Request for Additional Information - SDCC Reg. Ref. SD22A/0156

Development at Plot 100, Profile Park,
Nangor Road, Clondalkin, Dublin 22

Figure 5 – View 15

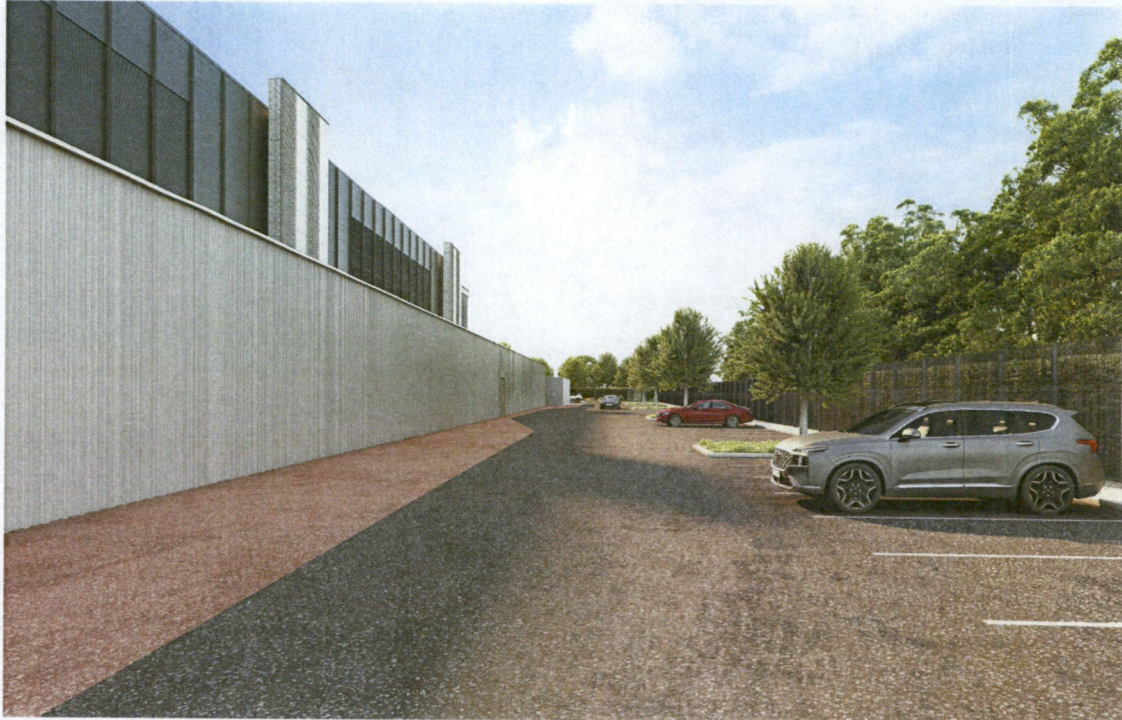
*- The applicant is requested to provide revised elevations detailing the correct orientation of each elevation.
- given the overall length of the building, the Planning Authority would welcome more localised visuals, indicating in particular the north, south and west elevations. This should include a visual incorporating the entrance plaza with DB8.”*

View 15 – View of the area north of the DB8 Building with the wall to Emergency generators compound visible on the left, visitors car parking area in the centre and green hedge and row of trees screening the DC site from the Nangor Road.
